Memorandum

Subject: Response to Testimony Related to Pipelines

Project #s: PWB: W02563 BC: 152606

Date: May 5, 2025

Photo 8: Taken February 27, 2025 shows water that was running under the FWI gravel pad and down the shoulder of SE Lusted Road. Since this picture was taken, a berm was built forcing the water to a small well with a pump that discharges water back to the grated catch basin.

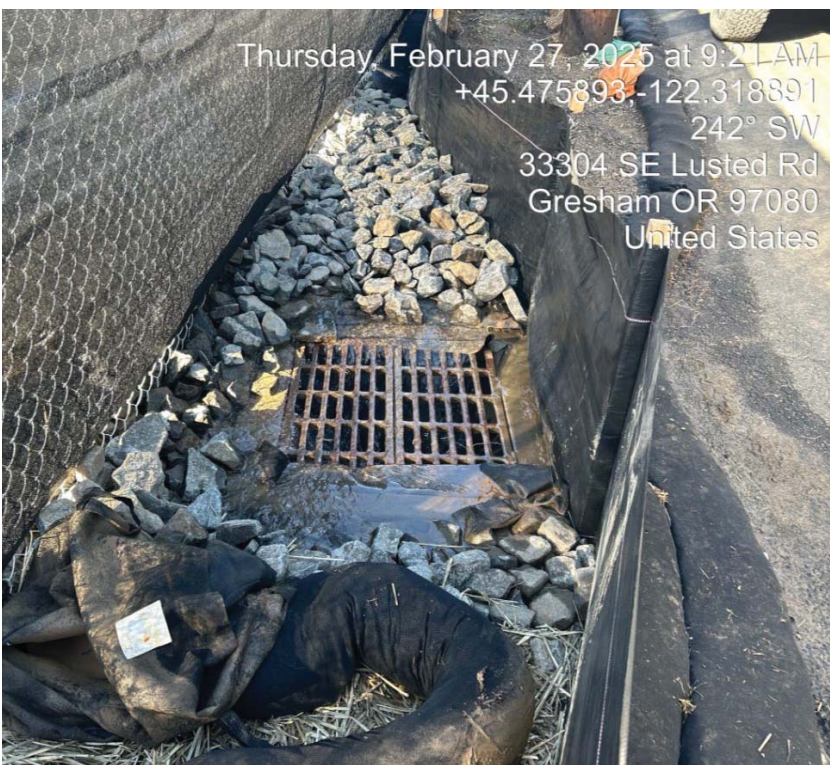
“Beaver Creek is also being adversely affected by the PWB Filtration Plant construction on Lusted Road. An area of field that never had water runoff has been packed and graveled, so it is no longer permeable. I have documented on several occasions muddy water running off this site and down the road into Beaver Creek.”

In response to the damaged drain tiles at the FWI site in February, the contractor temporarily re-routed the water emerging from the damaged subsurface drain tiles to an above ground pipe (where it previously had been connected underground to the black vertical HDPE pipe shown in the Photo 1 above). Twenty-four inches of gravel base was also added to the FWI site to stabilize the muddy ground and help slow surface water sheet flowing across the property.

To accomplish the re-routing of the broken drain tile, a 6" HDPE temporary drain line was installed across the site from the broken drain tile area to the existing grated catch basin. A silt fence was also installed around the stockpiled soil along with straw wattles and straw bales to slow and filter overland surface flows before getting to the catch basin. A berm has also been added on the east side of the FWI site to provide a means to capture and contain drainage within the site and redirect water back into the catch basin through a 24" dewatering well and sump pump system that includes passing all water through sediment filter bags (see Photo 12 below). As shown in the photos below, these changes and improvements provide better means of maintaining the water quality leaving the site and controlling the site drainage.

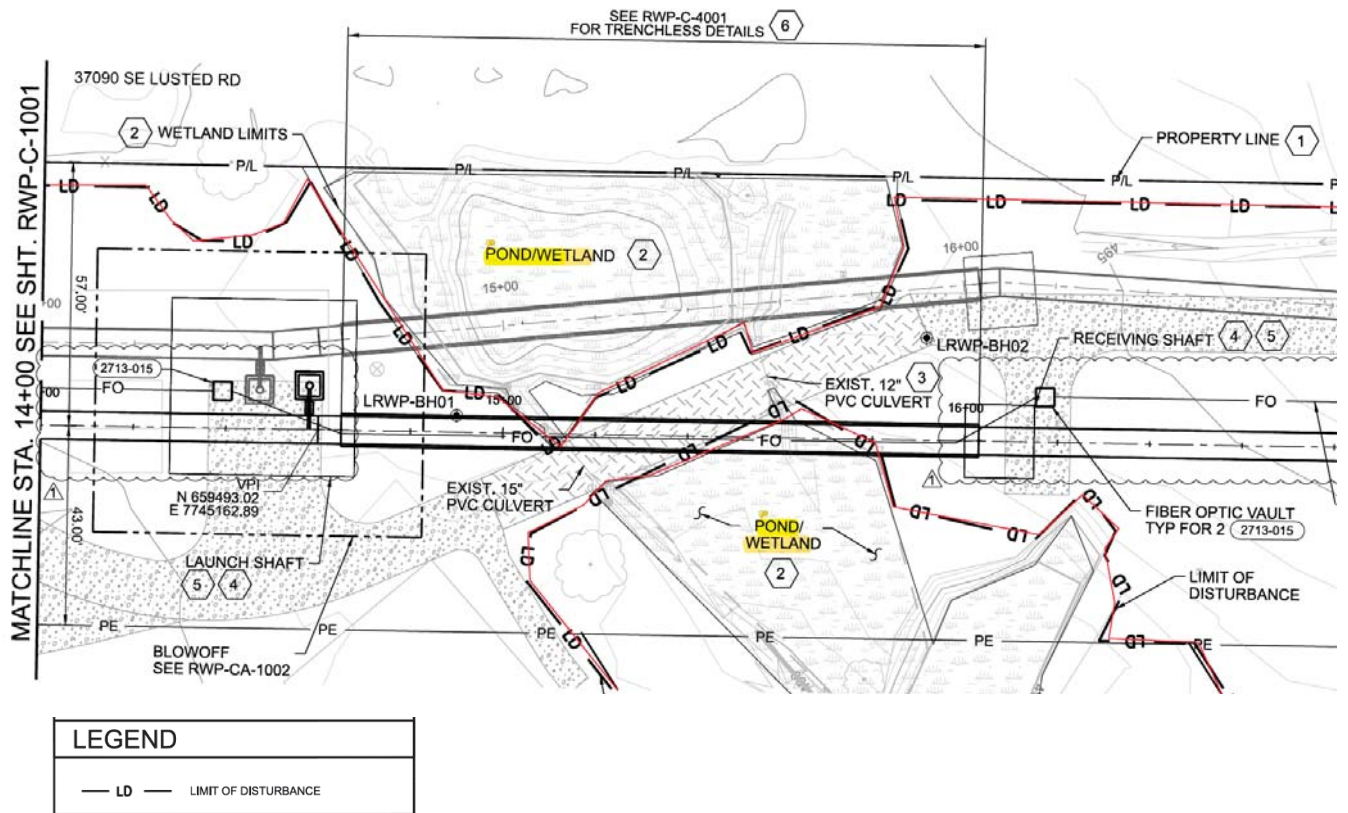
“In the fall of 2024, PWB began equipment staging and site preparations at the property adjacent to the raw water pipeline portal on SE Lusted Road. Significant modification to the property was completed to accommodate heavy equipment, construction materials, and construction traffic. This disturbance has inherently impaired natural resources since the start of construction activity, including surface water, wetlands, and associated wetland habitat. Site preparation resulted in the removal of at least 24 trees (> 6 inches in diameter) and an undetermined loss of existing shrubs. Contrary to Winterbrook’s report on habitat survey results that were conducted on October 19, 2021 (Exhibit G.1), a wetland features do exist on the affected properties (Figure 6). Exhibit G.1 nor any other evidence submitted into the record acknowledges the existence of the pond or wetland.”

Winterbrook provided wetlands delineation and obtained Department of State Lands concurrence with that delineation, which is included in the record in a separate memorandum during the first open record period. The PWB survey team accounted for the boundary of this delineation as a part of the design process on the identified raw water pipeline property. Specifically, the design avoids impacts to: 1) the pond south of the existing road (Water #2 in the delineation), the wetland surrounding the pond (wetland #3 in the delineation), and 3) the wetland north of the existing road (wetland #4 in the delineation). Pre-construction, the wetlands had always been separated by a farm access road with property owner installed culverts that prevented the pond from overflowing onto the farm road. Both the pond and the ditch associated with the wetland on the north side of the road are human-made features of the property. The design team developed solutions to avoid impacts to the wetland and pond by boring the two pipelines beneath the pond using a trenchless installation system. In addition, the farm road and existing culverts were protected by requiring the contractor to install a hardened road surface (described further below), reducing the heavy loads on the existing farm road and property owner culverts to avoid any damage. As described below and in the memorandum (submitted concurrently with this memorandum into the record) prepared by the project's wetland expert, Anita Cate Smyth of Winterbrook (the "Winterbrook Memo"), the constructed road surface also allowed construction access without disturbing the nearby pond and wetlands.

The wetland and pond delineation limits have been included on construction drawings and are designated as wetlands, as shown in this example section (note that north is down):

As shown on that construction drawing, the wetlands are outside of the construction limit of disturbance. A black sediment/silt fence has been installed to provide protection to the wetland. No activities are permitted to occur beyond this sediment fence into the wetland areas.

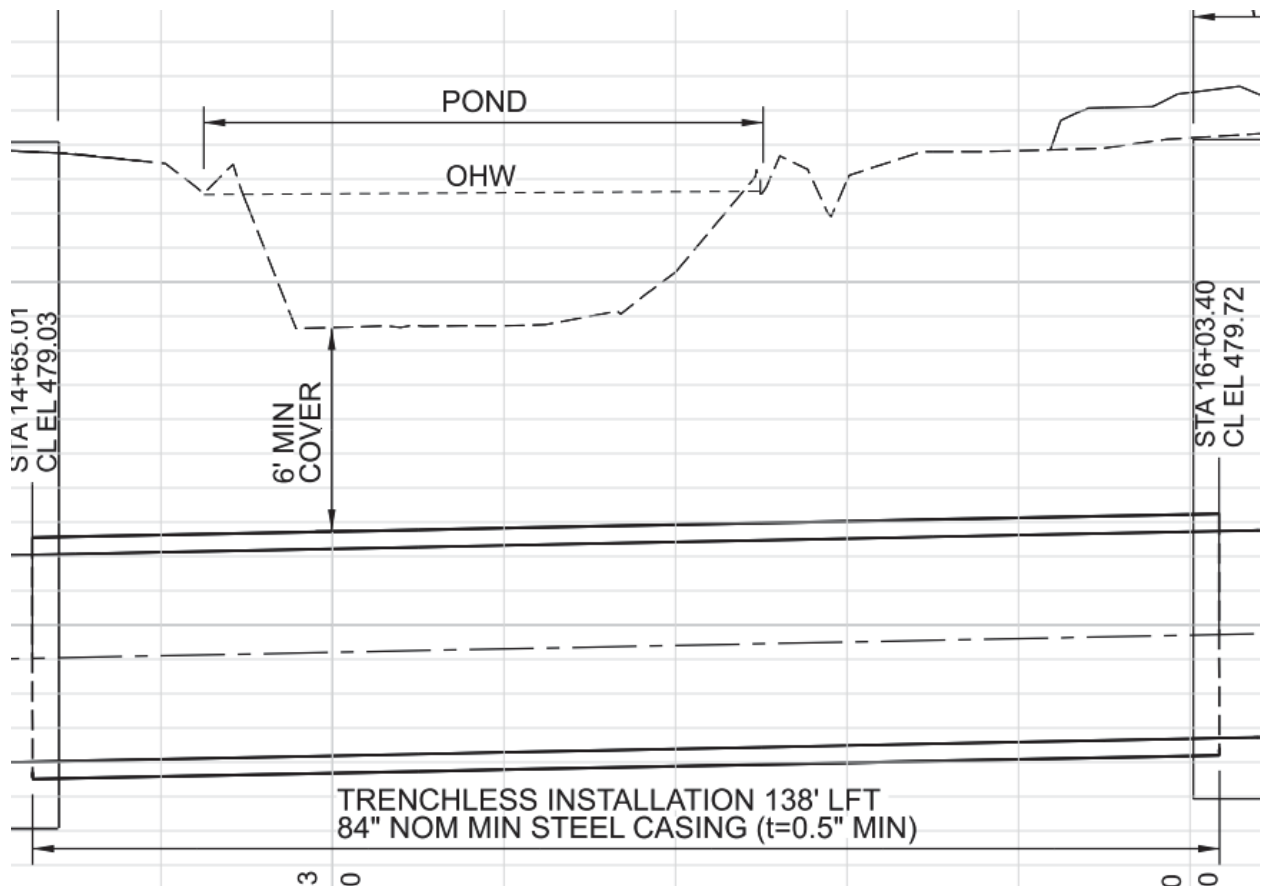
“Sheet LU100 (existing conditions raw water pipelines) shows the location of 2 ponds. The CU narrative fails to provide any evaluation of their ecological value or condition. The Applicant has apparently failed to conduct a wetland delineation to determine the location or extent of jurisdictional wetlands within this area or other proposed project areas. Instead, the Applicant’s CU narrative assumes that auger boring the 2 large pipelines under one of the ponds is sufficient evidence that adverse impacts to natural resources are avoided. Lacking a wetland delineation

and full inventory of mammals, avian, and amphibian species, it is impossible for the Applicant to make any such conclusion.

It is now clear that a wetland delineation was never completed. Without baseline information PWB cannot provide evidence to support a finding that wetlands were not adversely impacted by the site alternation or the ongoing operation of the raw water pipelines.

See response to Exhibit N.43, Page 14.

Additionally, boring the pipeline under the pond/wetlands area will not adversely affect the pond/wetlands. The permanent installation of the pipelines in this area includes an outer steel casing installed a minimum of six feet below the deepest point of the pond/wetlands. The pipeline carrying the raw water to the filtration facility is then placed inside the steel casing.

The pond/wetlands sit above an impermeable soil layer that allows it to store water. That impermeable soil layer will not be pierced by installation of the casing or

pipeline inside of it. Use of a tunneled casing and grout sealing the annulus outside of the casing further establishes that there will be no pathway or connection between the water in the pond/wetlands and pipelines. Once the pipe is installed in the casing, the annulus space between the piping and the casing will also be filled with grout, which further prevents flow paths of water under the pond/wetlands from escaping through or around the casing and pipe.

The pipeline installation will be 11 feet below the ground surface (wetland), and laterally the construction entry and exit points ("pits") will be 20 feet from the top of the bank on the east side and 50 feet away to the west side. Both the pits will be well outside the delineated wetland area.
